Site Name: Site Location: Superior, WI

Subject: RE: Action Requested by 01/31/2024, C. Reiss , 02-16-589248: Supplemental Site Investigation Report

Attachments: C.Reiss Stormwater Pond Construction - 2024.02.08 Photo Log.pdf

Photograph ID: 10

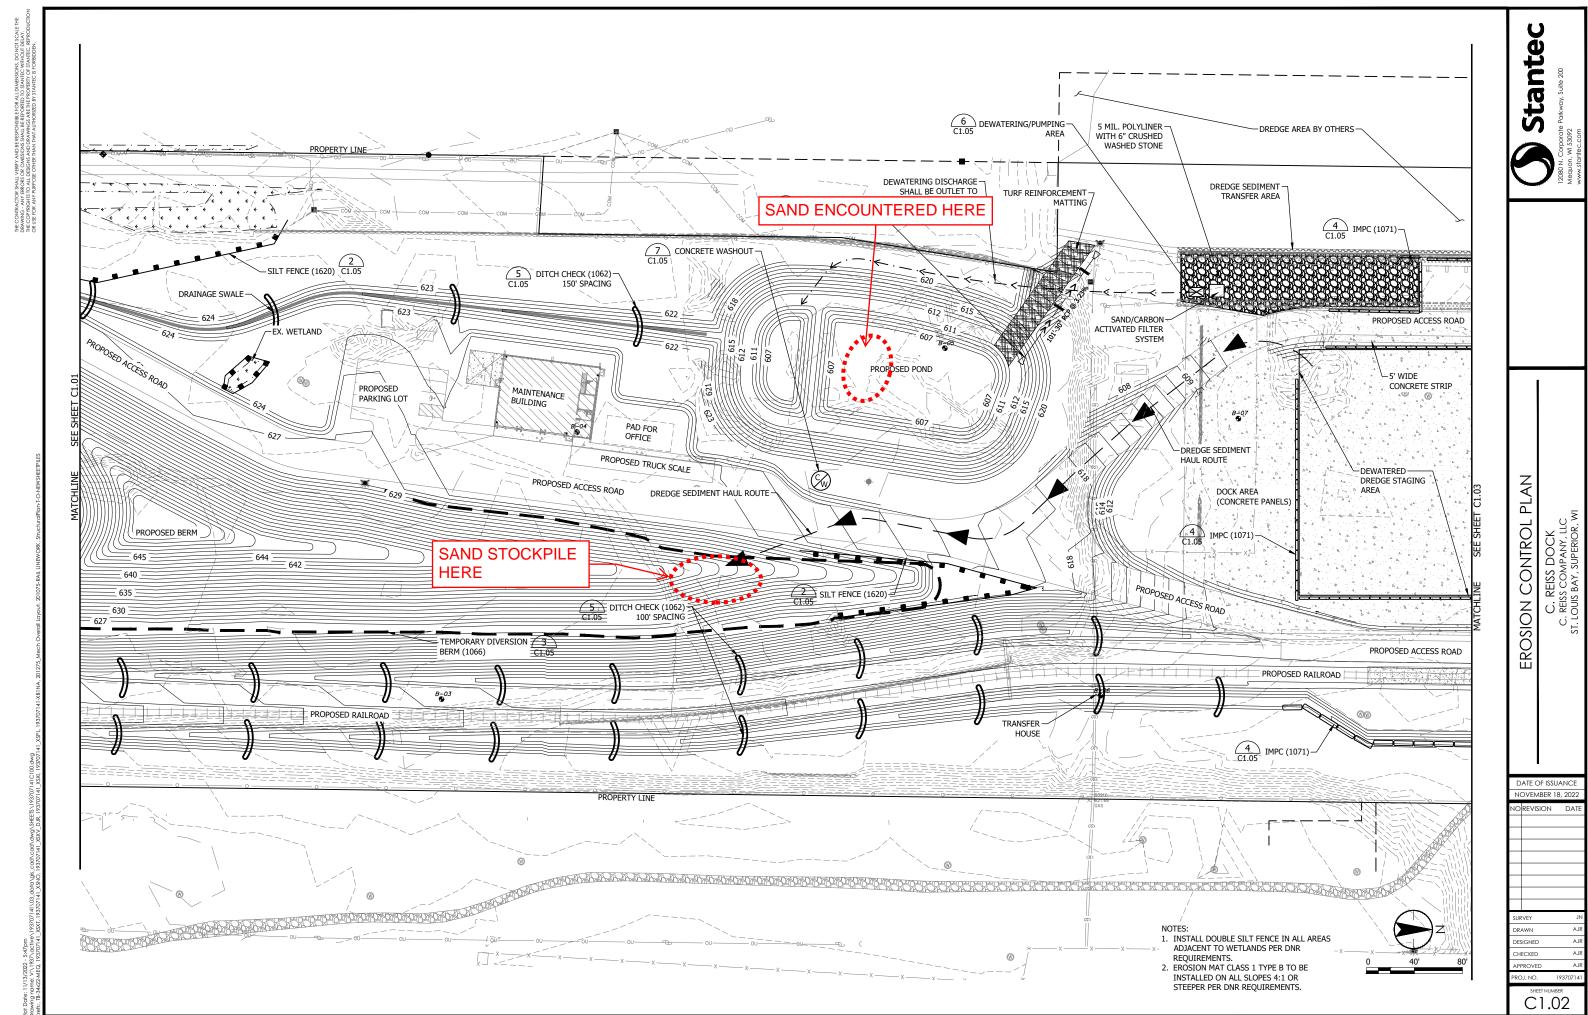
Sand Pile capped with clay
